Subject: Customer and dealer notification of defect on Gold Motor Homes
equipped with Girard awnings

Subject: Safety Bulletin – Gold Motorhome Awning Module Wiring Inspection

Models: Gold Motorhomes Coach # 71475 to 72122

**SAFETY BULLETIN - Awning Control Module
04-001**

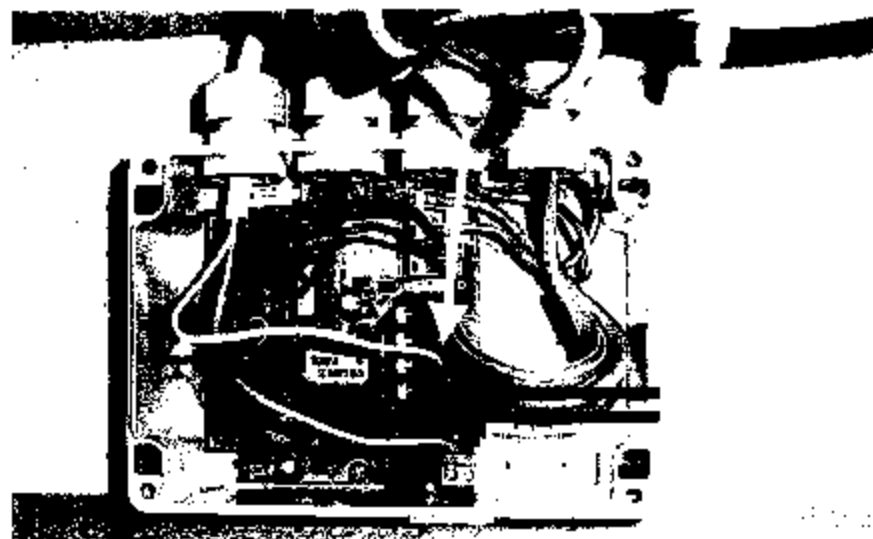
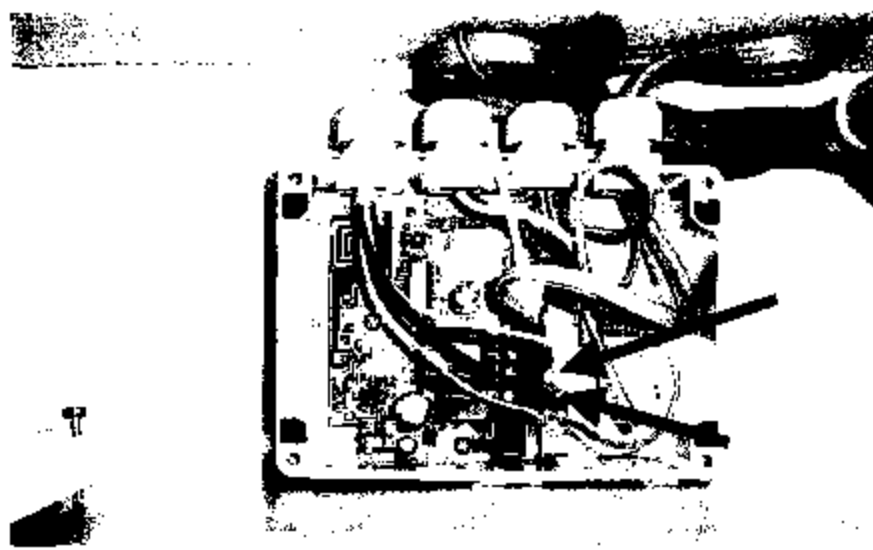
The correct wiring of the panel as shown, white wire, over black, over red.

The incorrect wiring of the panel as shown, white wire, over red, over black.

**In the event the module is incorrectly wired simply change the positions of the red and black wire to the correct positions. Reinstall module cover to complete.
Completion Reporting and Reimbursement**
